CITY PLAN COMMISSION STAFF REPORT

CD-CPC-2026-00067

Highland Plaza West Lot 2

Major Amendment to Approved Development Plan

1 LANDSCAPE PLAN

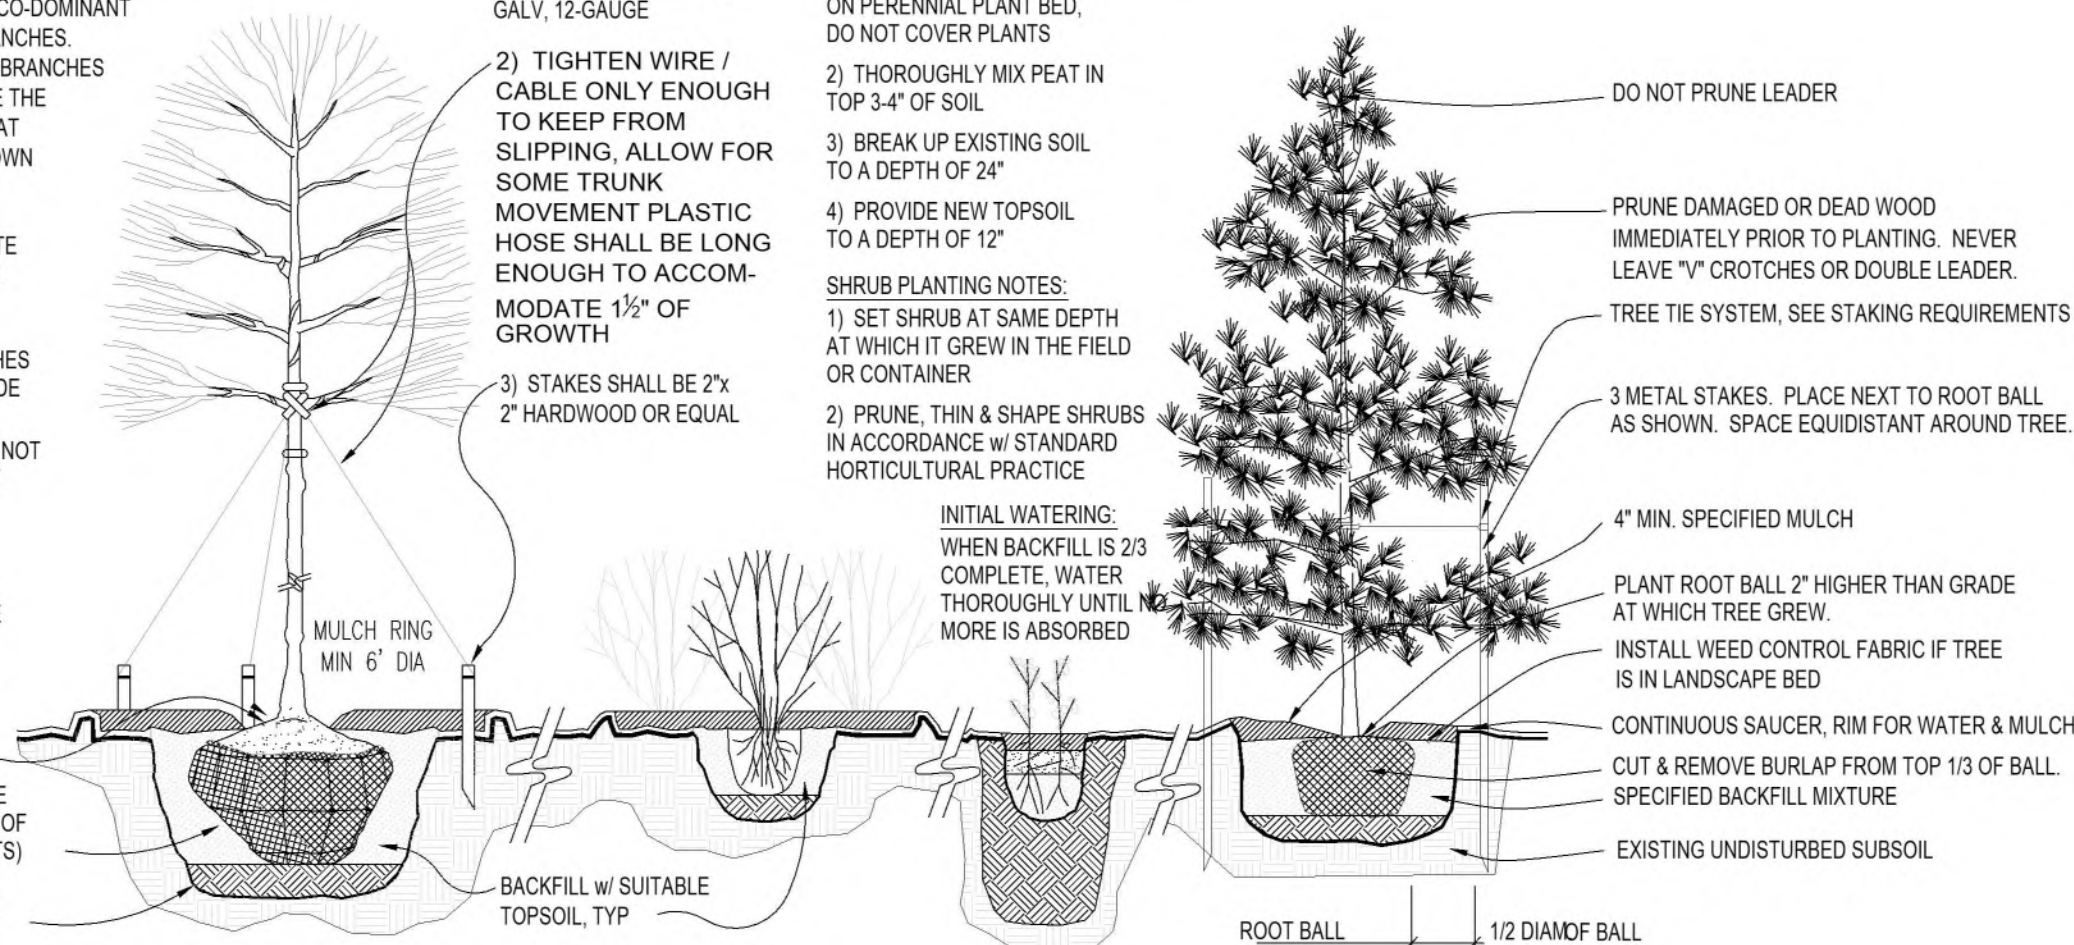
The concern is the proposed Landscape Plan, specifically the west (back slope) of development site consisting of approximately 30 feet in depth from Barrington Woods property lines to proposed parking lot and current retention basin and the entire length of proposed development from Kiddie Academy to GoodWill. This area adjoins west facing townhomes on N Home Ave.

The proposed Landscape Plan states to preserve existing vegetation. This vegetation consists of scrub trees, brush, weeds and tall grasses. This is unsightly for the fourteen homeowners whose lots adjoin this vegetation where they view the overgrowth from their patios and windows. It is also unsightly for the east facing townhomes who must view it from their porches and for the many people who walk our tree lined street. The brush encroaches onto the adjoining lawns as there is no containment. Homeowners have reported ticks and undesirable wildlife.

I am requesting that existing vegetation be removed including stumps and roots from stated area and the area be seeded, kept free of weeds and mowed at least monthly during the growing season of April through November.
